Traffic Assessment

- Responses to Comment Areas from February 4, 2021 Planning Board Meeting
 - Use of ITE Data
 - Trip Projections
 - Roadway Traffic Levels
 - Traffic Operations

Roadway Traffic Levels

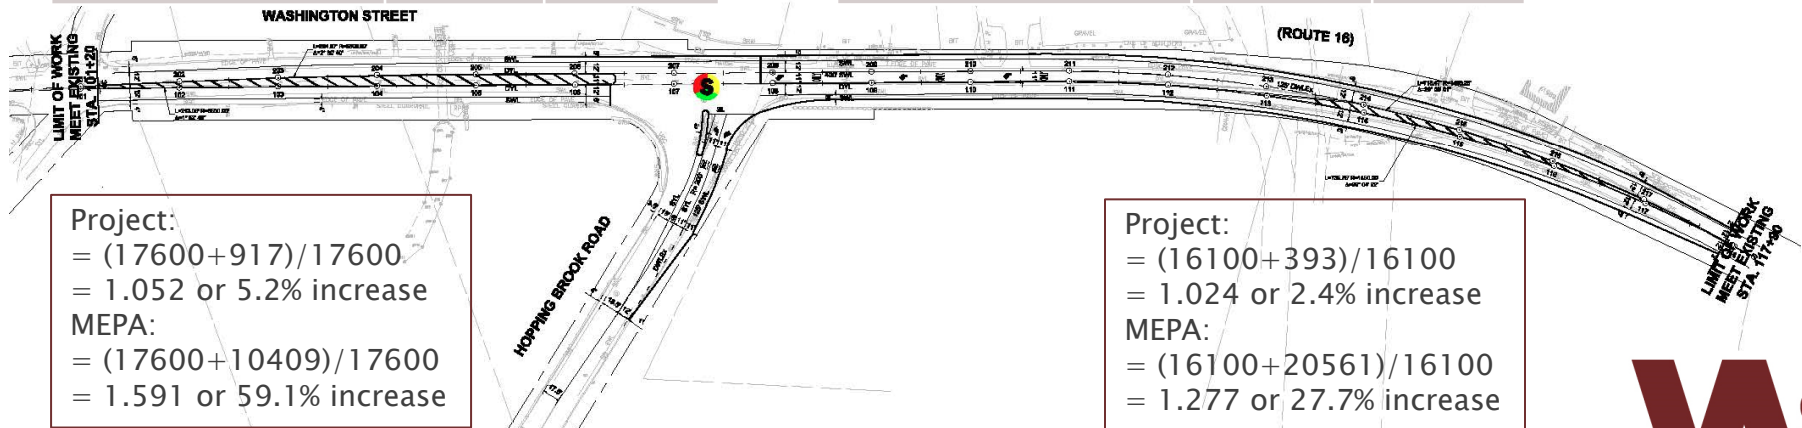
- Current phase of development represents a reduction in traffic from the approved and expected level of development.
- Results in a reduction in traffic increases on streets otherwise expected with the approved project.
- Washington Street traffic volumes, west and east of Hopping Brook Road due to the 800,000-sf warehouse phase and the MEPA-approved traffic levels:
